California Department of Fish and Game
North Central Coast Study Region
Feasibility Evaluation of Draft MPA Proposals
February 11, 2008

Draft Proposal 3 (TC)

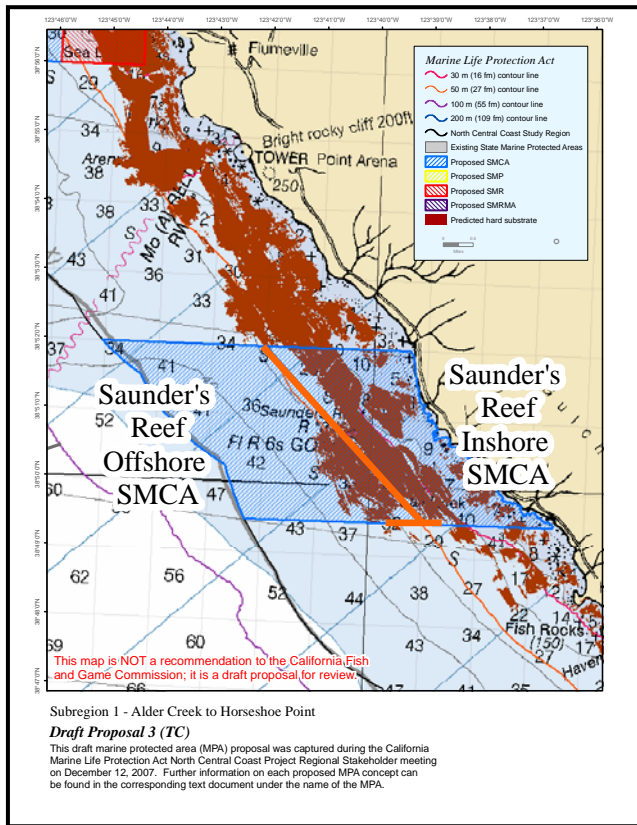
Point Arena SMR and SMCA: Floating corners were created in the north-eastern and south-eastern corners of Pt. Arena SMR. Offshore corners should be located at whole minute lines of latitude and longitude (see: general suggestions for improving the feasibility of the draft proposals; bullet #2). The eastern boundary of the SMR is not easily enforced and the MPA should either extend farther east or be moved far enough offshore to make enforcement simple.

- Floating corners are difficult to enforce.

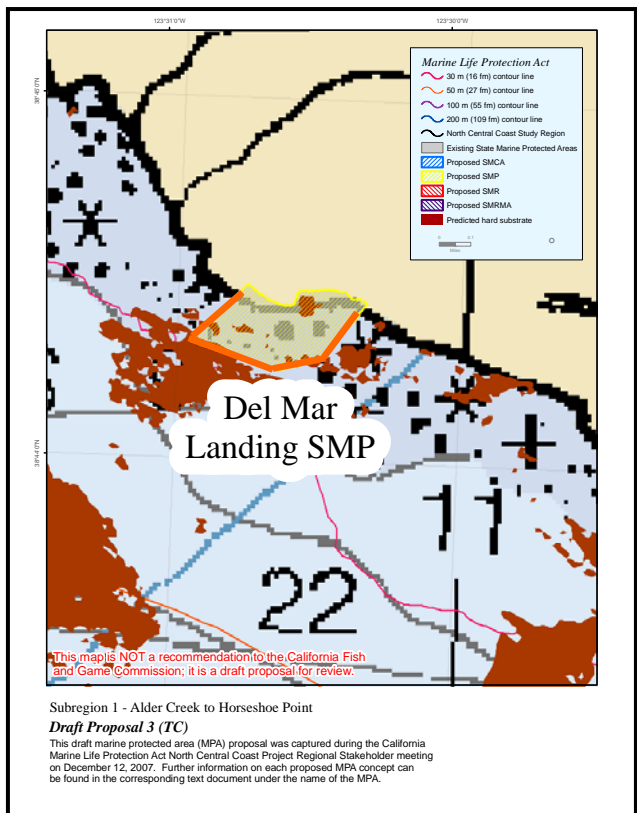
Saunders's Reef Offshore and Inshore SMCAs: Diagonal lines may be feasible when they follow the angle of the coastline and are anchored at whole minute points of latitude and longitude. The southern point of the diagonal line is not anchored at a whole minute line of latitude and longitude. The northern point of the diagonal line is described by a distance offshore and should be described using a whole number latitude and longitude.

Del Mar Landing SMP: Boundaries do not follow a north/south east/west orientation, are irregularly shaped and are not at easily recognizable landmarks or at readily determined lines of latitude and longitude.

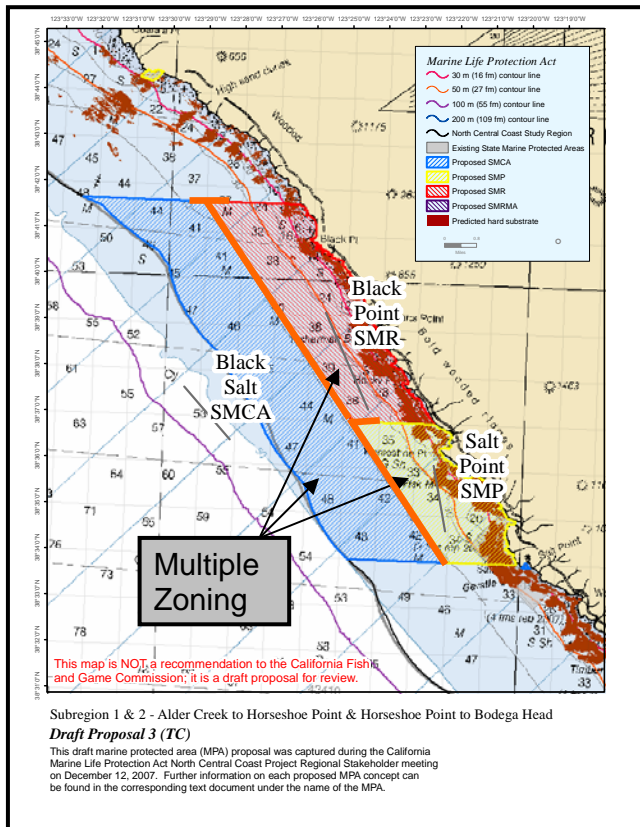
- These boundaries are difficult to enforce and prosecute in a court of law.

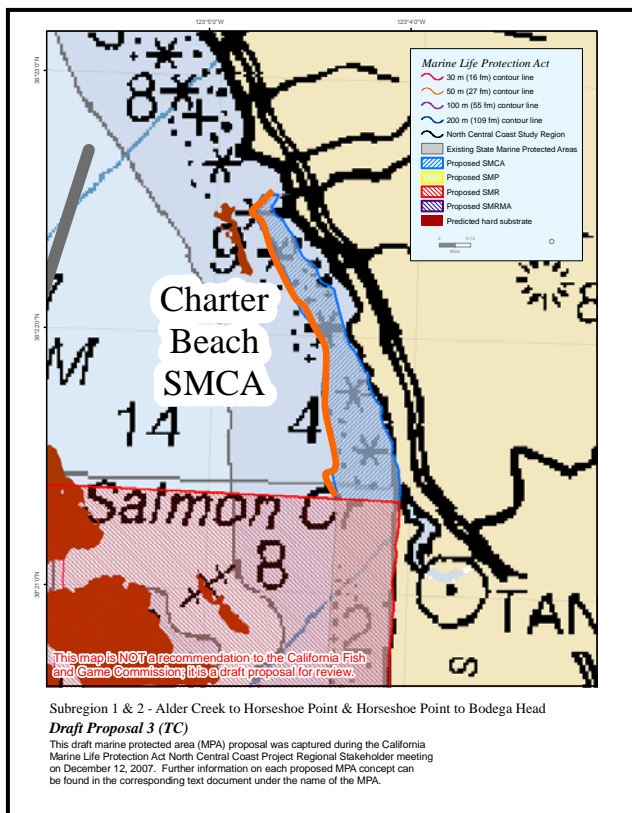
Black Salt SMCA, Black Point SMR and Salt Point SMP: Multiple zoning was created with Black Salt SMCA, Black Point SMR and Salt Point SMP. Multiple designations in a small area are difficult to enforce and create confusion among user groups. Diagonal lines may be feasible when they follow the angle of the coastline and are anchored at whole minute points of latitude and longitude. Unanchored diagonal lines were created for the western boundaries of Black Point SMR and Salt Point SMP.

- Enforceability and public understanding would be enhanced by simplifying this cluster.

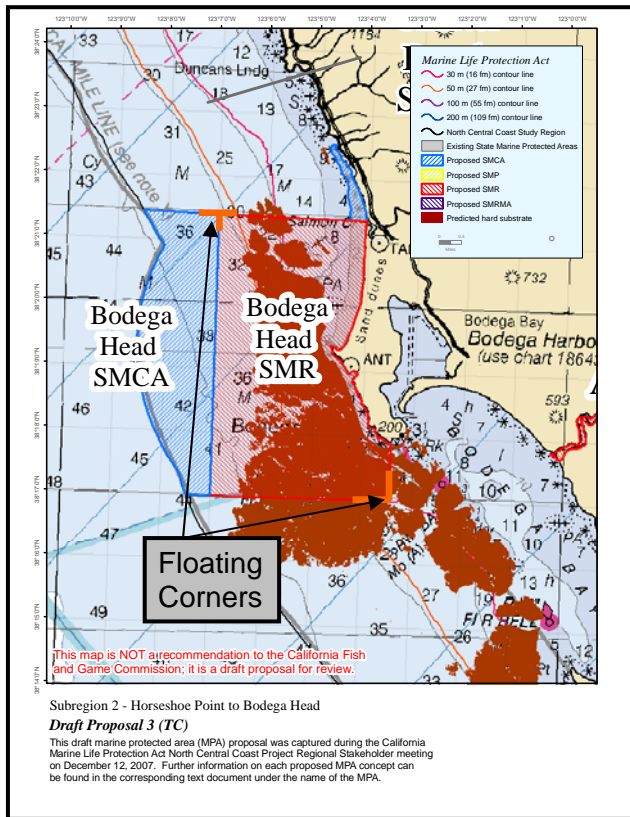
Charter Beach SMCA: Boundaries do not follow a north/south east/west orientation, are irregularly shaped and are not at easily recognizable landmarks or at readily determined lines of latitude and longitude. The offshore boundary is defined by a depth contour. The southern boundary is defined as "Salmon Creek parking lot" which is not considered an easily recognizable landmark.

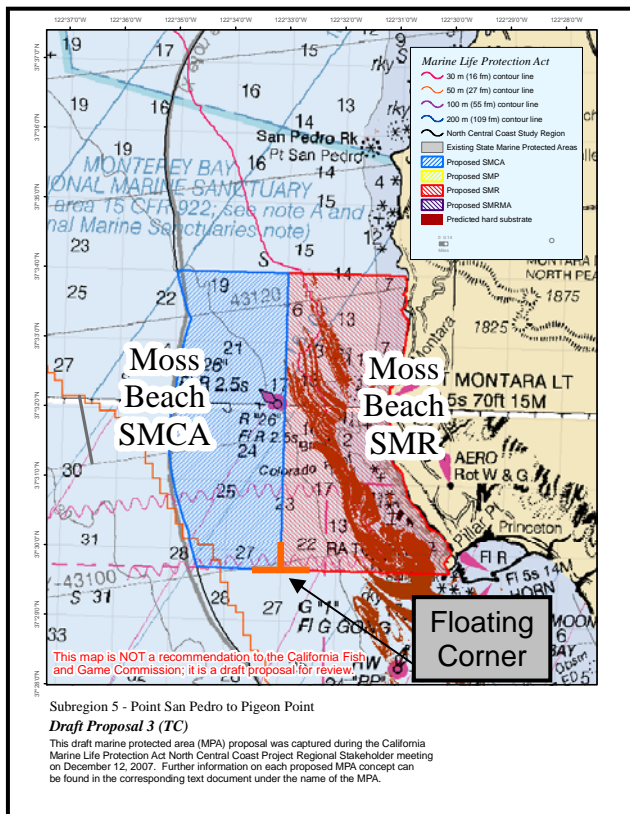
Bodega Head SMR and SMCA: The southern boundary is defined as "Salmon Creek parking lot" which is not considered an easily recognizable landmark. The south-eastern boundary of the SMR appears to be at an easily recognizable landmark. However, this is not certain because no description or lines of longitude were provided. Floating corners were created in the north-western and south-eastern corners of Bodega Head SMR. Offshore corners should be located at whole minute lines of latitude and longitude (see: general suggestions for improving the feasibility of the draft proposals; bullet #2).
